# **KINGSTON SOLAR LP**

## **Sol-Luce Kingston Solar PV Energy Project**

### **Summary of Project Modifications**

Figure 1:  
Property Boundary of the  
Project Location  
and New Lands

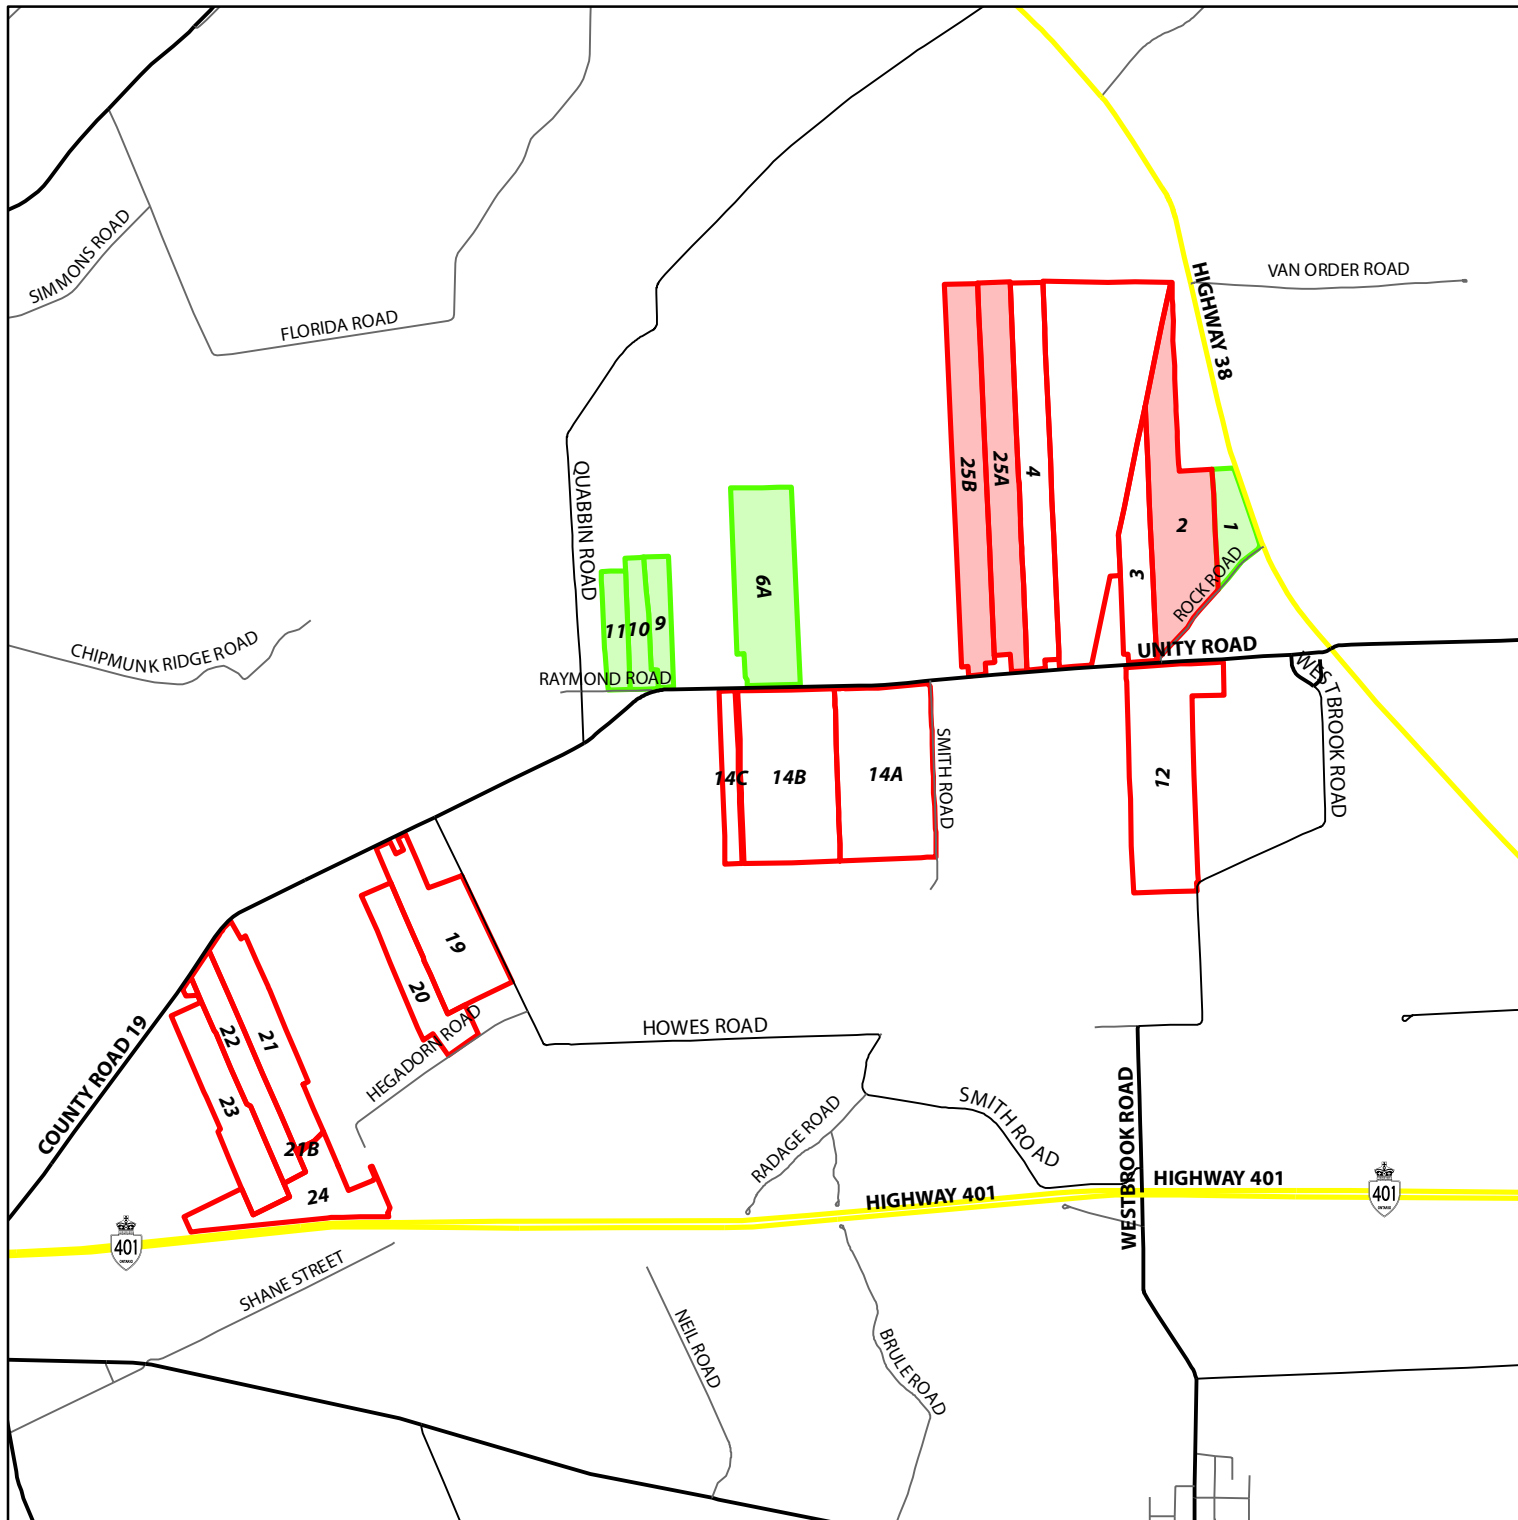
The amendments to the project are comprised of a Major Design Change (i.e., the reallocation of some project components to new lands – see Figure 1 and Figure 2) as well as smaller Technical Changes, primarily due to the availability of more efficient equipment, allowing for a reduction in the number of Medium Voltage Power Platforms (MVPPs) and alternate specifications for the panel modules.

Subsequent Stage 2 Archaeological Assessments were undertaken for the new lands (see Figure 1). New land are identified as Properties #2, 25A, and 25B) in October 2013 by Stantec Consulting. The assessment concluded that no further archaeological assessment of the new lands is required. The assessment was submitted to the Ministry of Tourism, Culture and Sport on October 23, 2013, and a comment letter was received on October 25, 2013. A copy of the comment letter is provided in Appendix A.

Figure 8  
Predicted Noise Level  
Contours at 1.5m Height

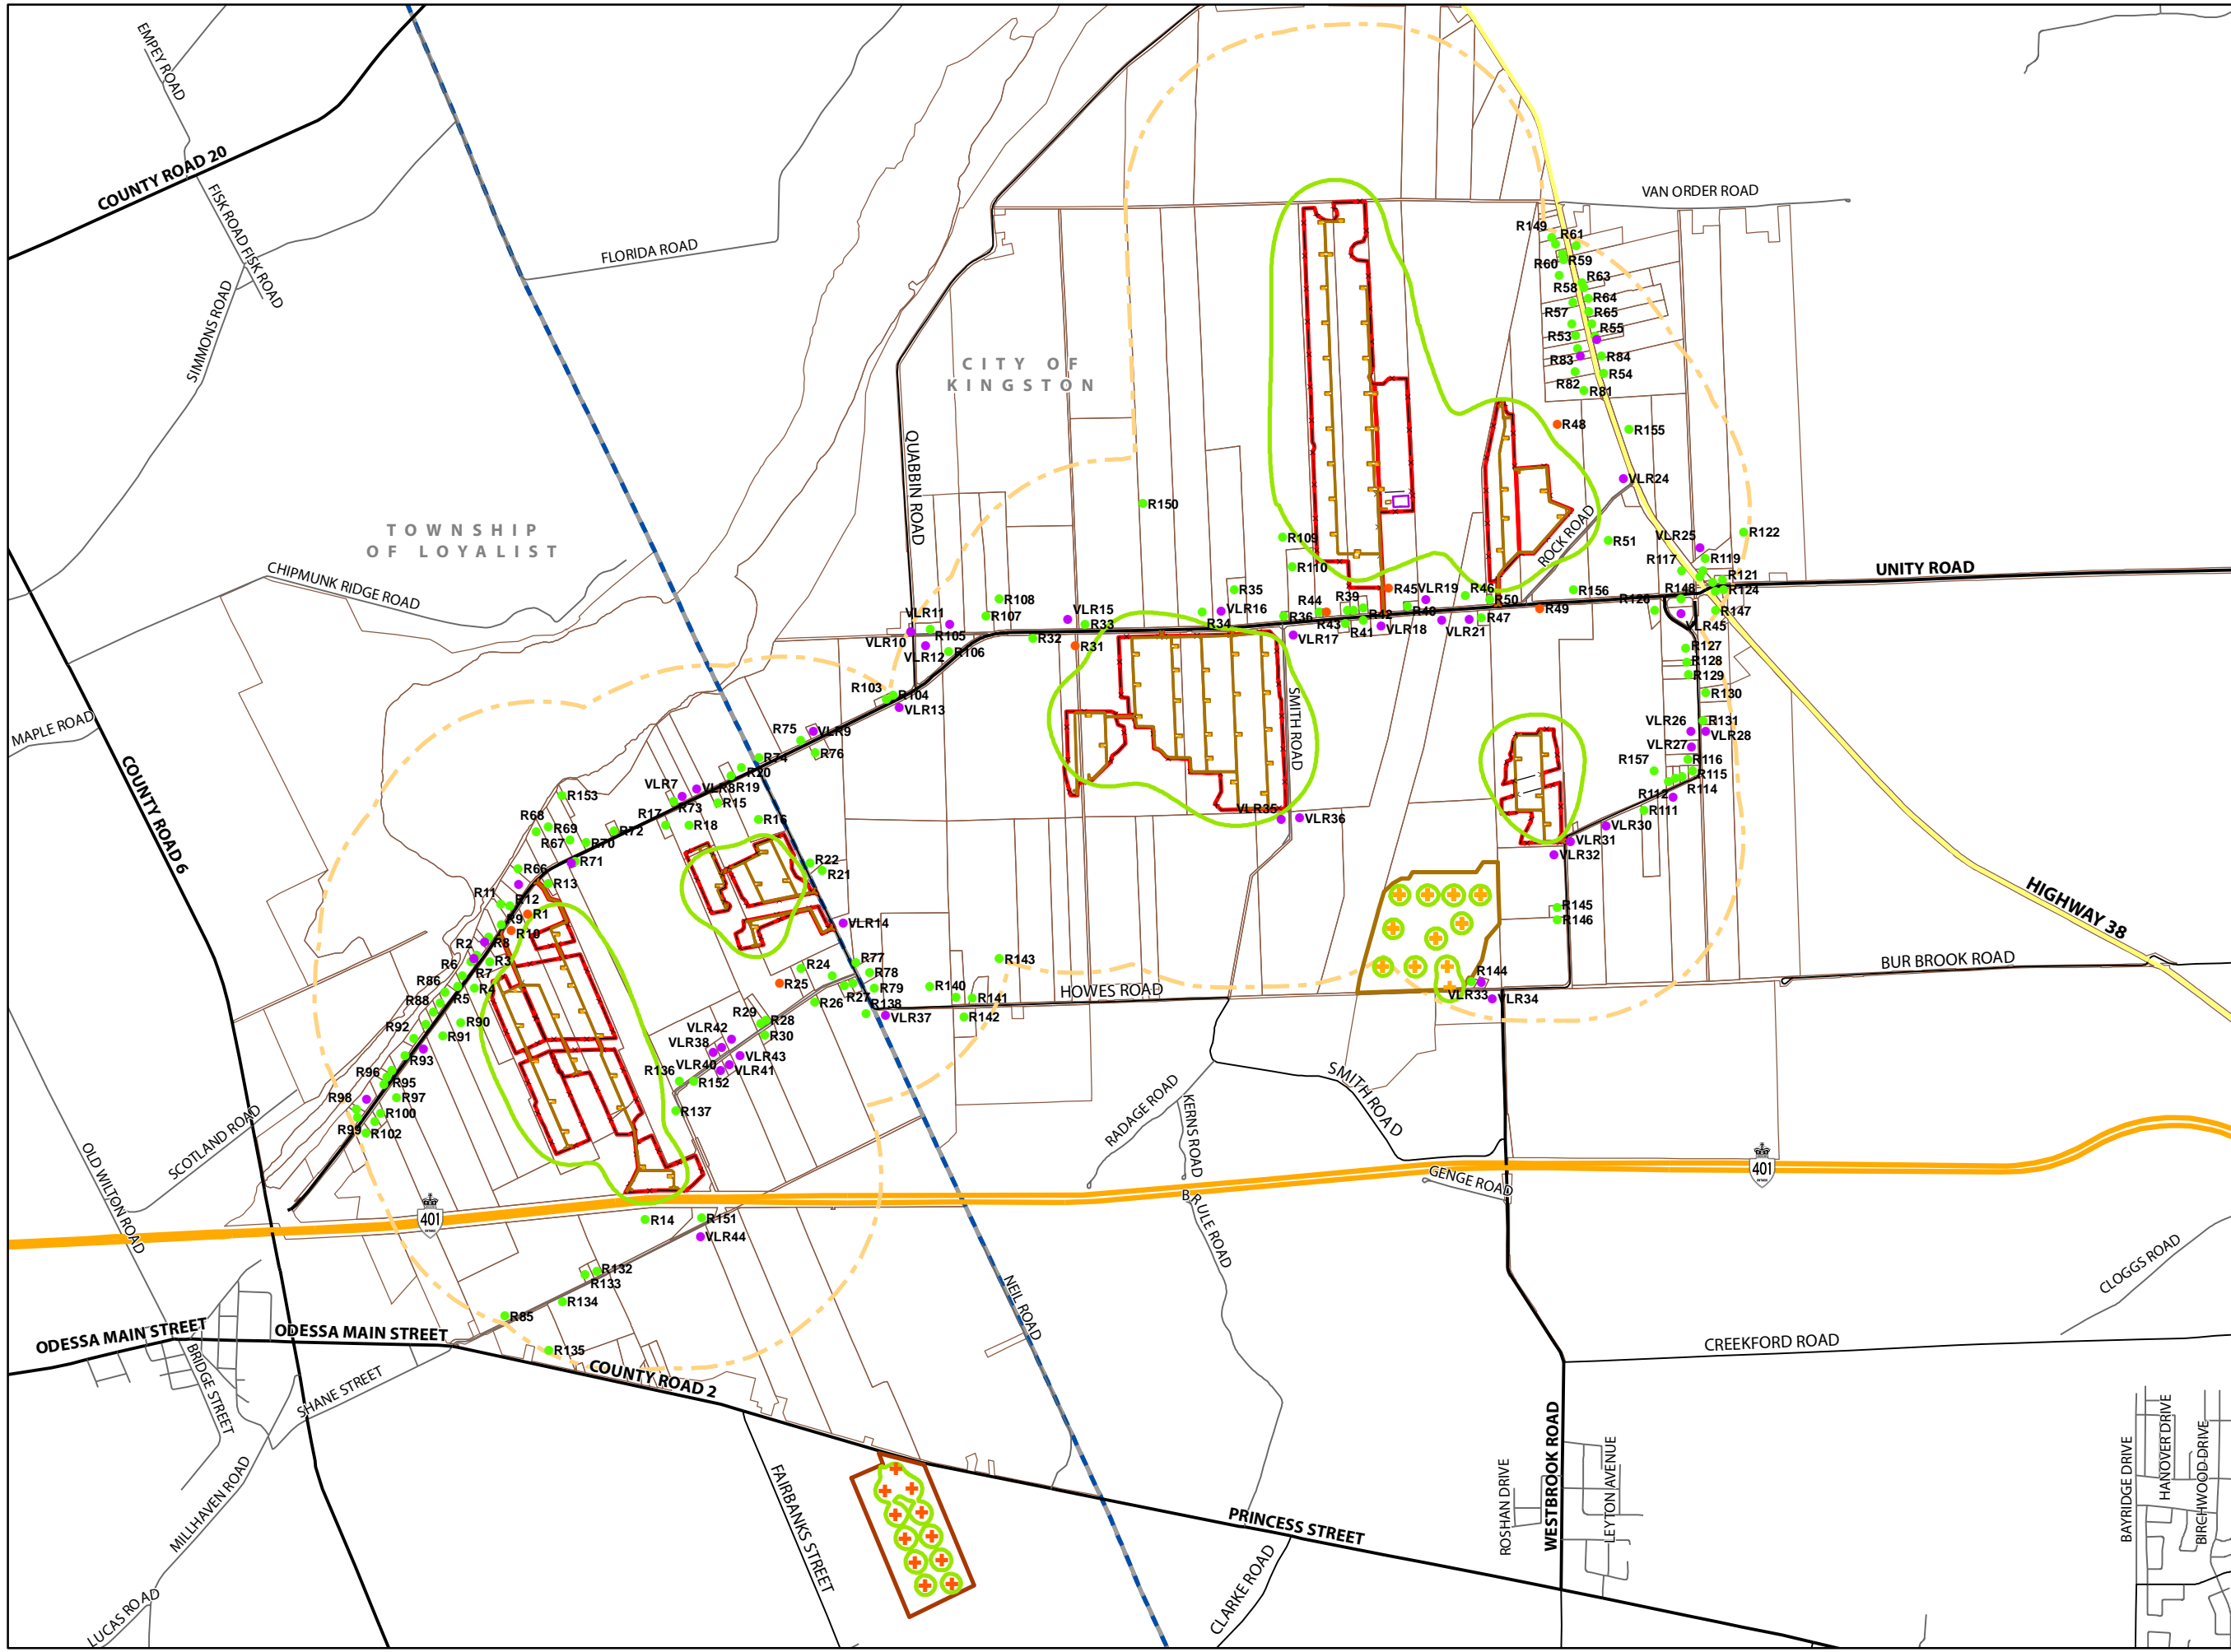
The *Noise Study Report* provides the results of noise modelling to demonstrate that the proposed facility meets the sound power level standards of the MOE. The original *Noise Study Report* indicated that no mitigation measures would be required to mitigate the noise from the 97 Medium Voltage Power Platforms (MVPPs) and one substation transformer associated with the Sol-Luce Kingston Solar PV Energy Project, or to mitigate noise sources from neighbouring solar facilities (SunE Westbrook Solar Farm and the Kingston Gardiner Hwy 2 South Solar Energy Project). The updated *Noise Study Report* concludes that the Sol-Luce Kingston Solar PV Energy Project can be constructed in compliance with MOE standards, provided that acoustic louvers are installed at 14 of the 78 MVPPs (see Figure 8 and Figure 9).
